SUBJECT: SUMMARY OF OCTOBER 27, 2010, PUBLIC MEETING OF THE
NUCLEAR REGULATORY COMMISSION TO DISCUSS FIRE
PROTECTION CIRCUIT FAILURES

**NRC PUBLIC FIRE PROTECTION CIRCUIT FAILURES MEETING
LIST OF ATTENDEES**

NRC Meeting
October 27, 2010
NEI 00-01 Revision 3

Slide 5

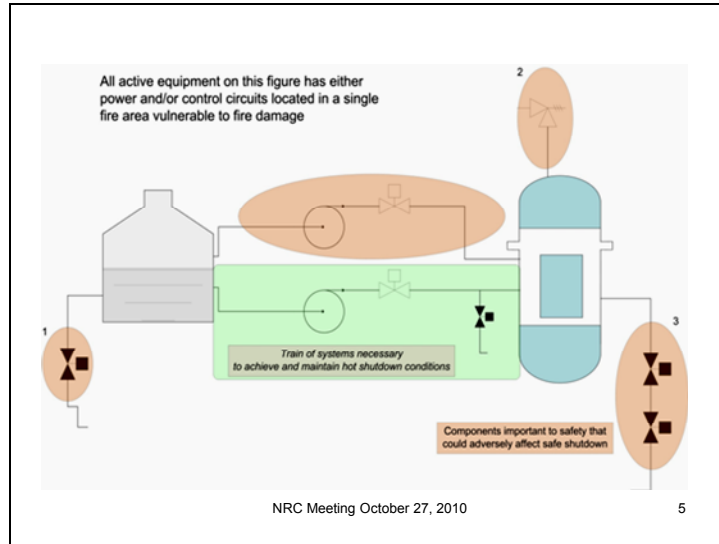
Slide 5 – Industry representatives indicated that one change to NEI 00-01, Revision 3, was to consider heating, ventilation and air conditioning (HVAC) equipment as important to safe shutdown. Mr. Gorman stated that this change was to make NEI 00-01, consistent with Regulatory Guide (RG) 1.189, Revision 2, “Fire Protection for Nuclear Power Plants.”

Slide 18

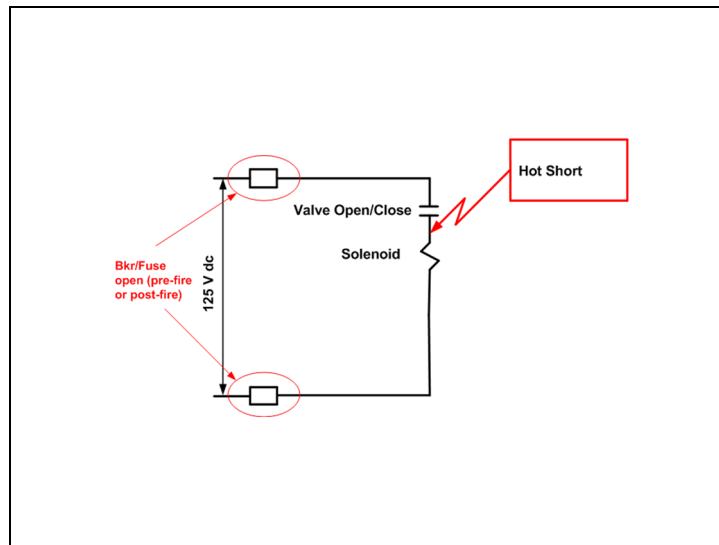
Slides 14 to 17 – Industry representatives indicated that “latching” in the context of these slides may not need clarification. Industry representatives indicated that use of the information on slide 17 would be on a case-by-case basis, and be appropriately documented.
